**TOWN OF BAY HARBOR ISLANDS
MORRIS N. BROAD COMMUNITY CENTER
1175 95TH STREET
BAY HARBOR ISLANDS, FL 33154**

DEVELOPMENT & REVIEW COMMITTEE MEETING

RESPONSE LETTER TO COMMENTS ROUND #1

PROJECT: BAY HARBOR LUXURY TOWNHOMES

ZONING SET
PROPOSED
1ST & 2ND
FLOOR
PLAN

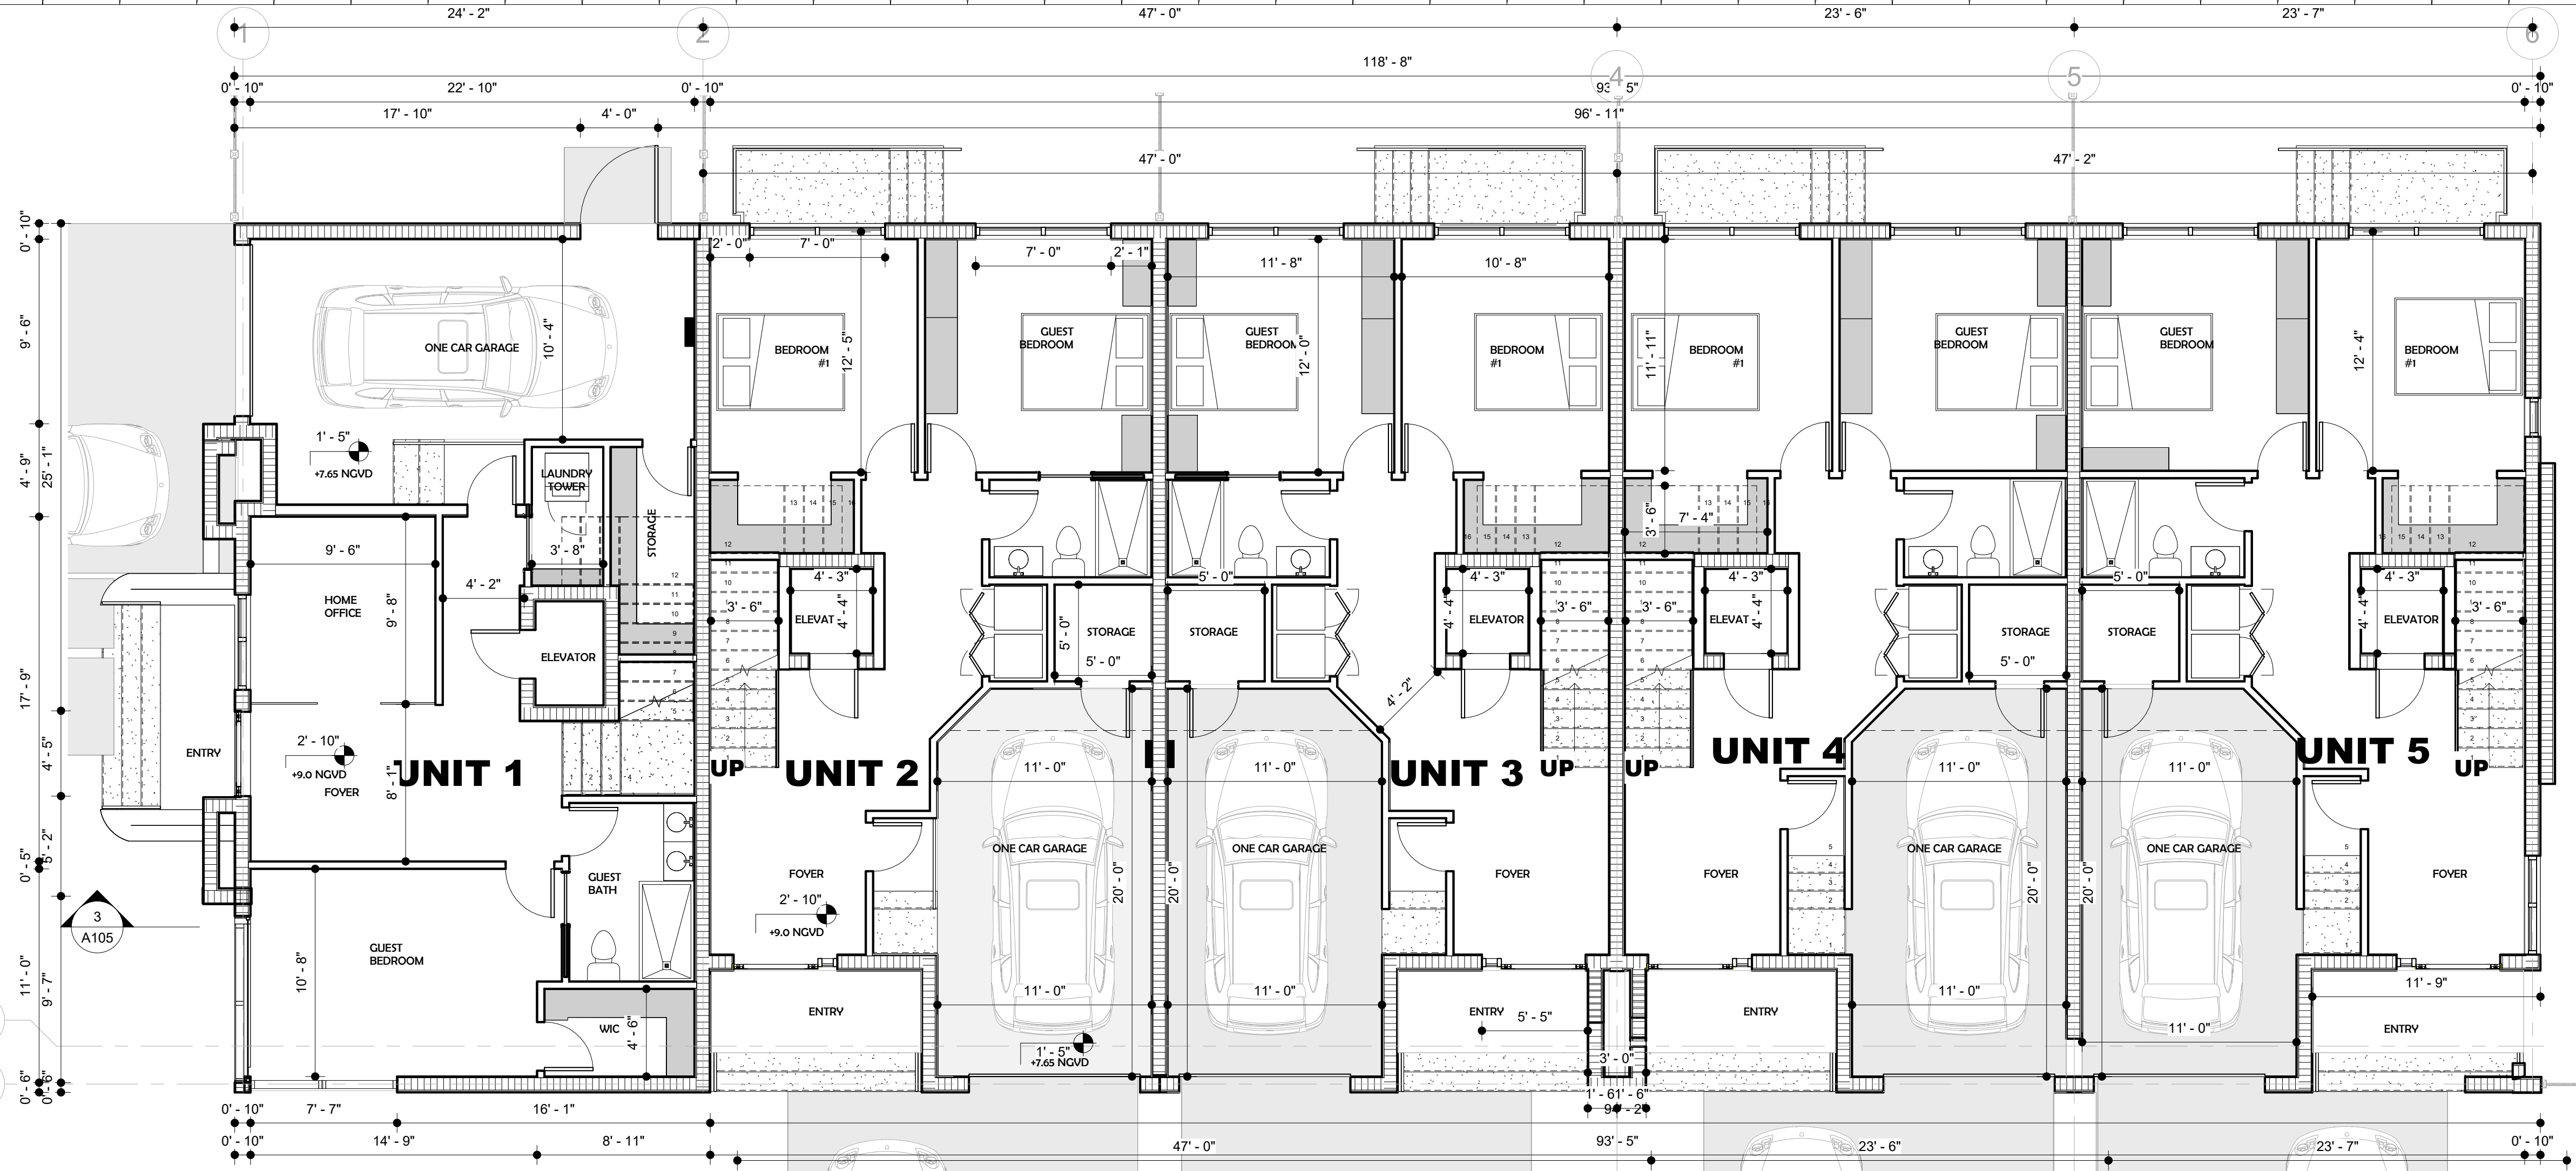
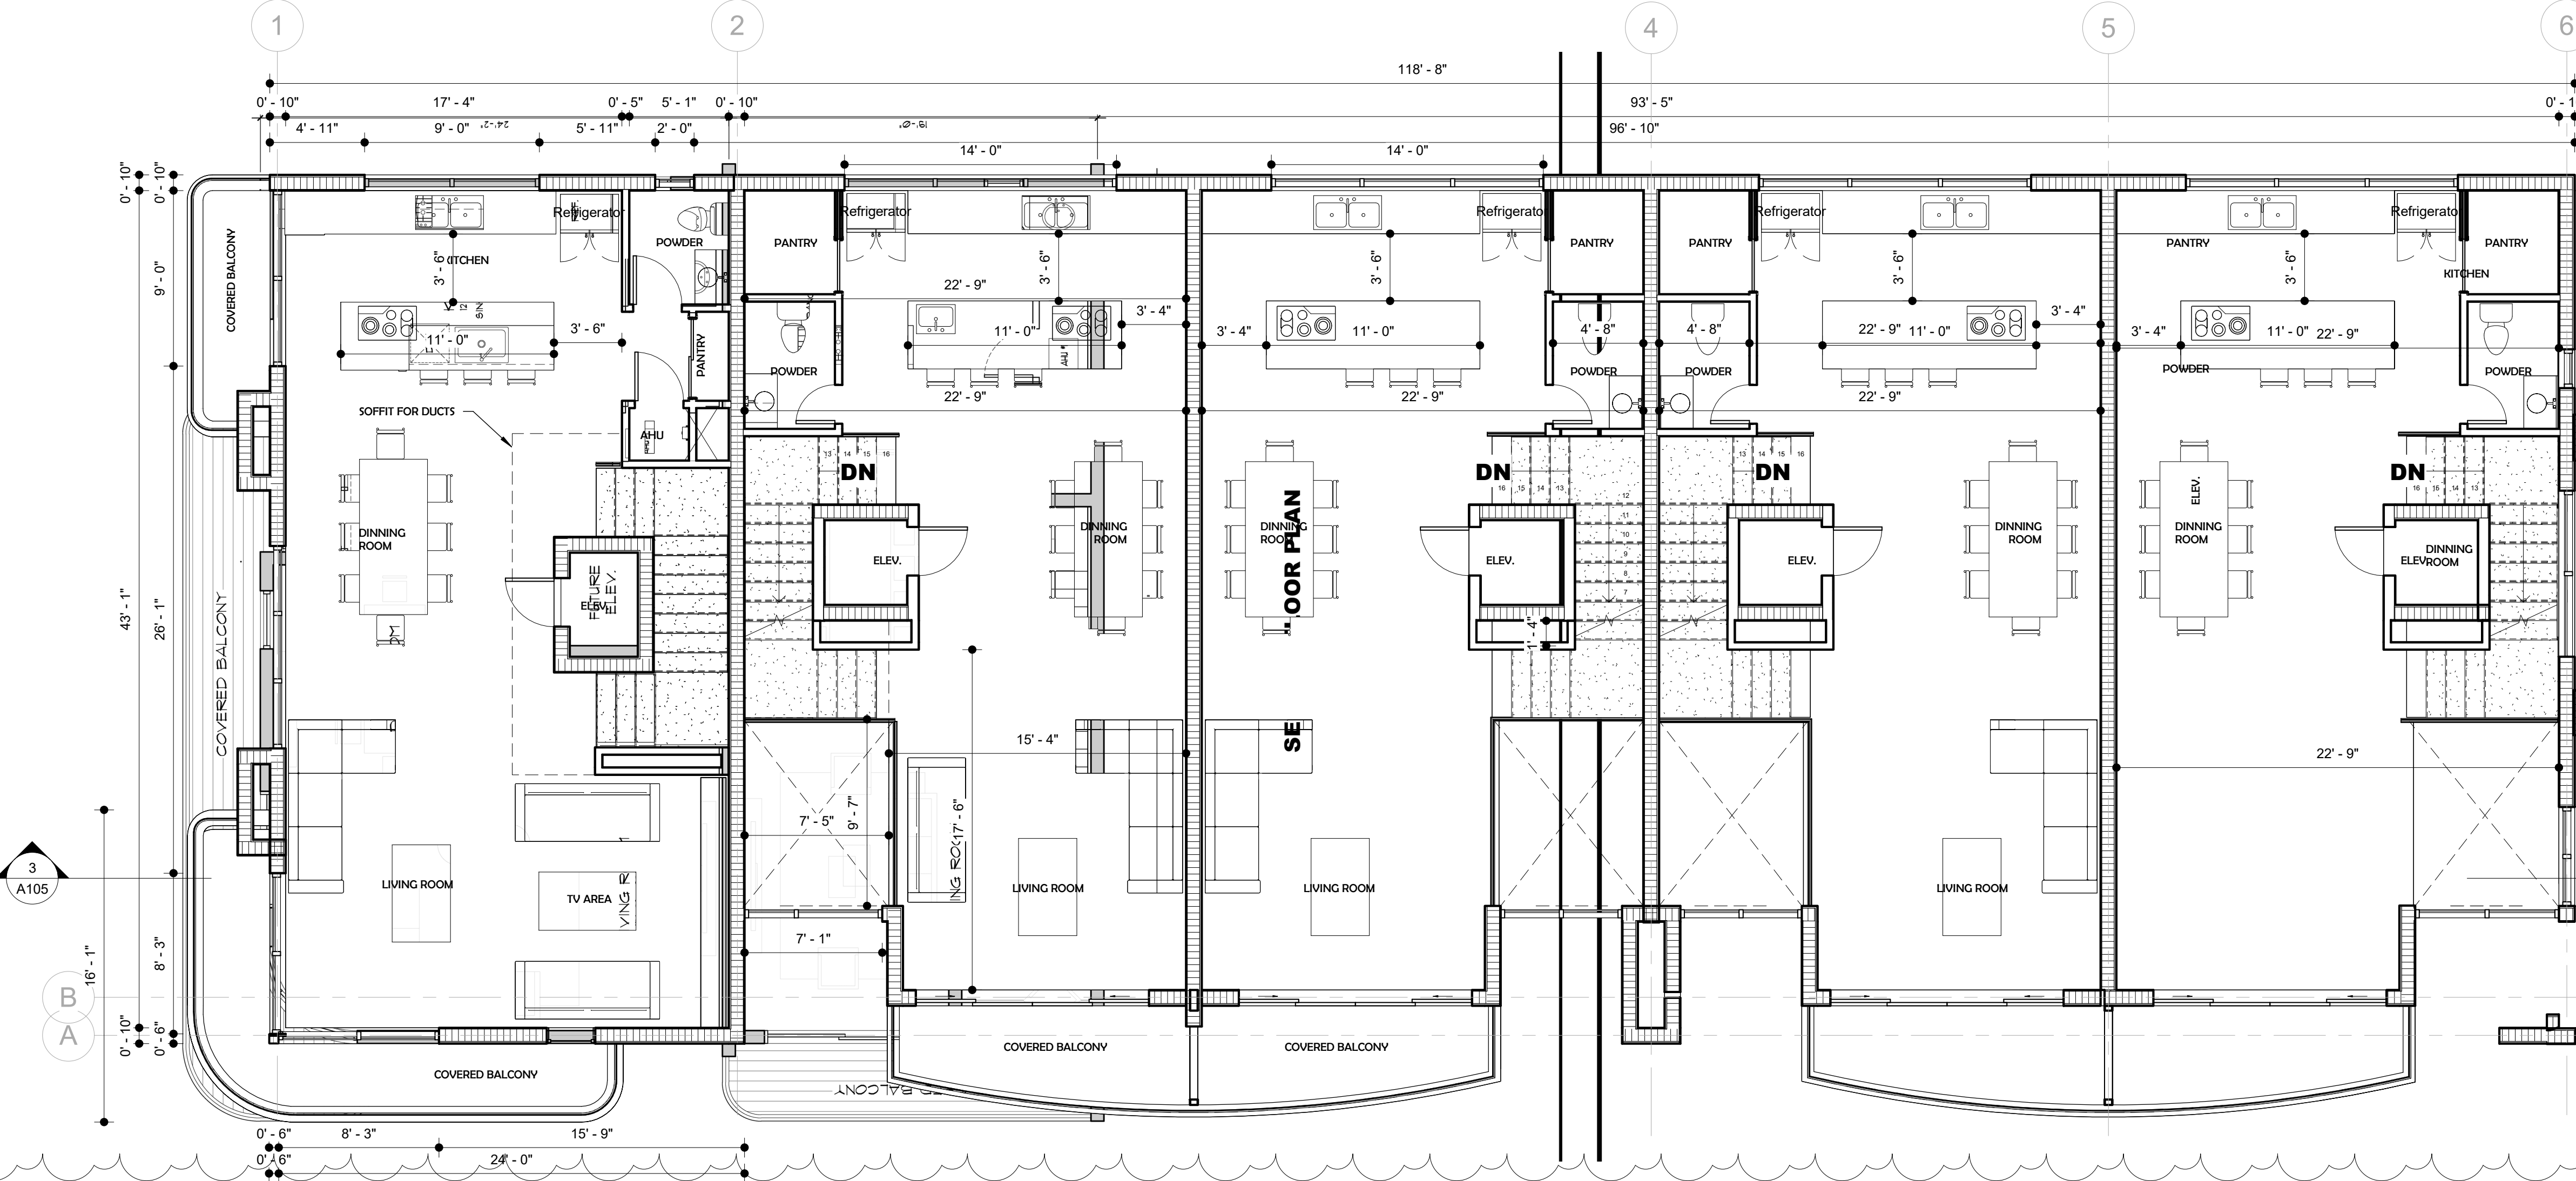
9. PER SEC. 23-9 EACH UNIT MUST PROVIDE A SEPARATE STORAGE AREA OUTSIDE OF THE D.U. PROVIDE DIMENSIONS /SF. FOR THE STORAGE. (MIN 25 SF)

R/ STORAGE AREAS PROVIDED AT EACH DWELLING, COMPLYING WITH REQUIREMENTS OS AREA AND HEIGHT. SEE FLOOR PLAN SHEETS A-101, A-107
